Access Compliance Report

Public Rights-of-Way

(Pedestrian Signals)

Intersection ID: N/A	Main Street:	Cross Street: N/A	Location: N/A
ADA ID: 1D2EEA263715	Signal Type: One Push Button-Non APS	Overall Compliance: No	Severity Score: BTN 1: N/A BTN 2: N/A No BTN: N/A
Codes/Mitigation Info/Possible Solution		Field Measurements/Component Compliance

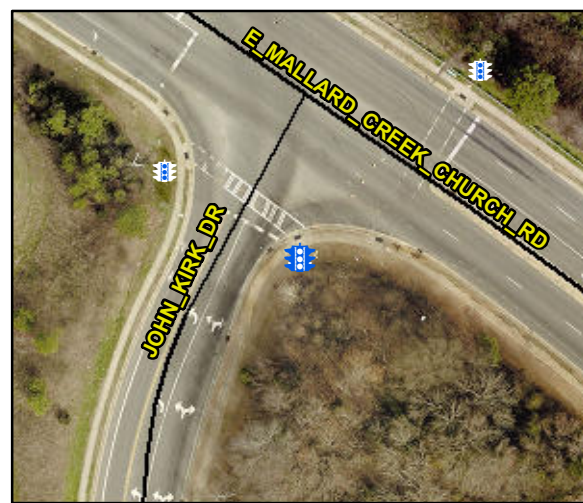
Possible Solutions: Replace Signal Push Button With APS Button on New Post. Remove & Relocate Sign.

PROW/ADA: TMUTCD 4e.08, R404.1, R404.7.1, R404.7.2
